# COUNCIL DECISION REQUEST

SUBJECT: McLane Park Preliminary Plat Extension

# PRELIMINARY PLAT McLANE PARK

Re: S-130-06, Preliminary Plat – McLane Park

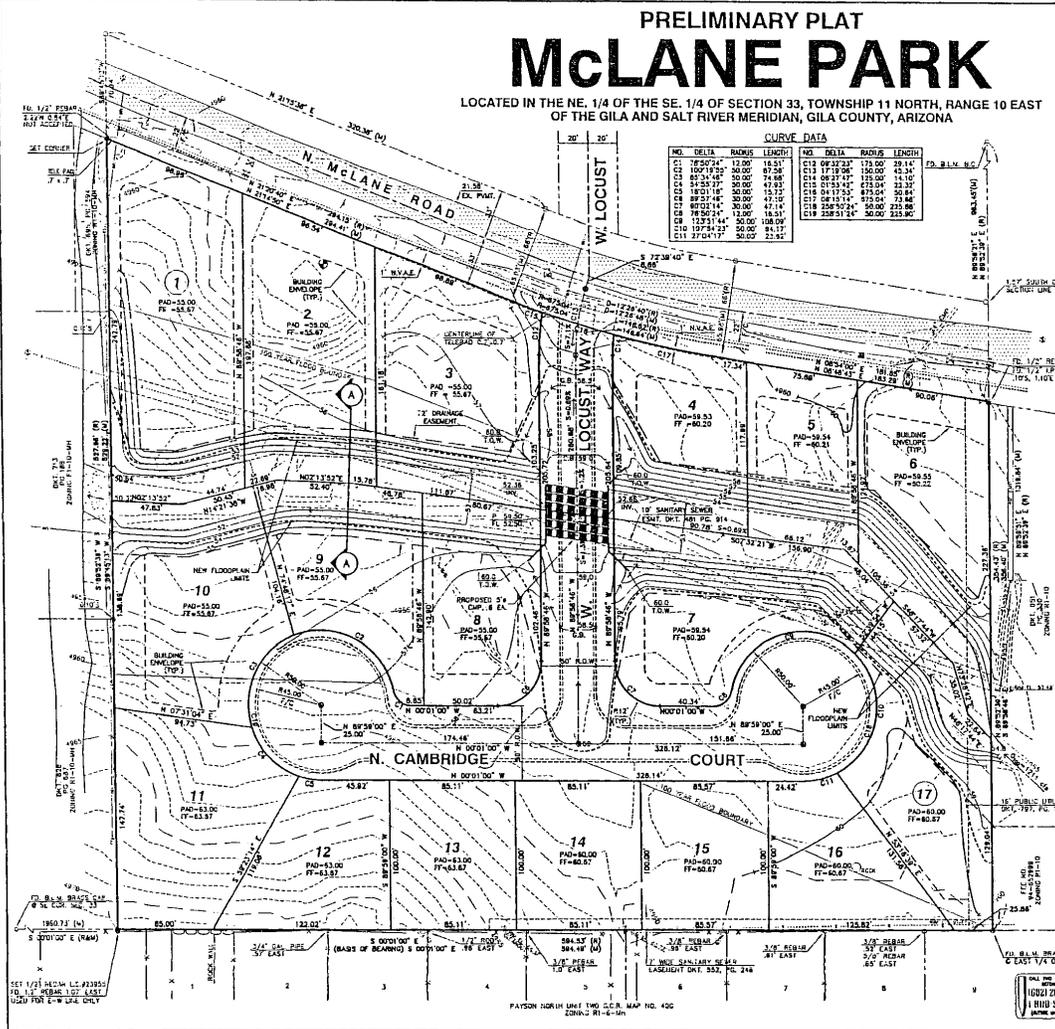
1. The final plat shall be in substantial conformance with the preliminary plat as submitted.
2. Prior to final plan approval and final plat approval, the developer must obtain an Army Corps of Engineers 404 Permit, an Arizona Department of Water Resources 401 Permit, and a Conditional Letter of Map Revision (CLOMR) from FEMA. The CLOMR must also address the effects of this project on the upstream and downstream properties.

3. Prior to final project acceptance and the issuance of building permits, the developer must obtain a Letter of Map Revision (LOMR) from FEMA. The LOMR must also address the effects of this project on the upstream and downstream properties.

5. The final subdivision plat shall indicate a minimum finish floor (FF) or minimum building pad (PAD) elevation for all lots based on the approved CLOMR.

6. Developer to provide all subdivision improvements, including storm water detention in accordance with the Town of Payson Requirements.
7. Channel access shall be designed to allow emergency vehicle access to cul-de-sac lots in the event of a 100-year storm.

8. All hydrant supply lines shall be a minimum of 8" diameter. Hydrants to be installed east of McLane Road at northern boundary of proposed subdivision and on the south side of West Locust Way, east of the channel and adjacent to lot 8.

9. The final plat shall grant a drainage easement enclosing all drainage channels on this project and a note shall be included on the cover sheet of the final plat stating: "This subdivision includes storm water conveyances within drainage easements. The property owners are responsible for all required maintenance of those drainage conveyances and easements on private property. The Town of Payson or other public agencies having jurisdiction, possess right of access for clearing, cleaning, or channelizing if not properly maintained by the property owner. All funds expended for this maintenance by the Town of Payson or other public agency will be charged to the individual property owner." The property owners are responsible for all required maintenance of those drainage conveyances and easements on private property and for any damage caused by the failure to properly maintain the same.

11. A note shall be included on the final plat stating, "Driveway construction on lots 1, 2, 5 and 6 shall be located such that the ingress and egress must be in forward motion towards North McLane Road only."

12. A 1' non-vehicular access easement shall be depicted on lots 1, 3, 4, 10, and 11 along the full length of the property lines abutting North McLane Road.

13. Lot Areas, in square feet, shall be depicted on the final plat.

14. A 4 foot minimum wide sidewalk shall be installed on both sides of North Cambridge Court and West Locust Way within this subdivision.
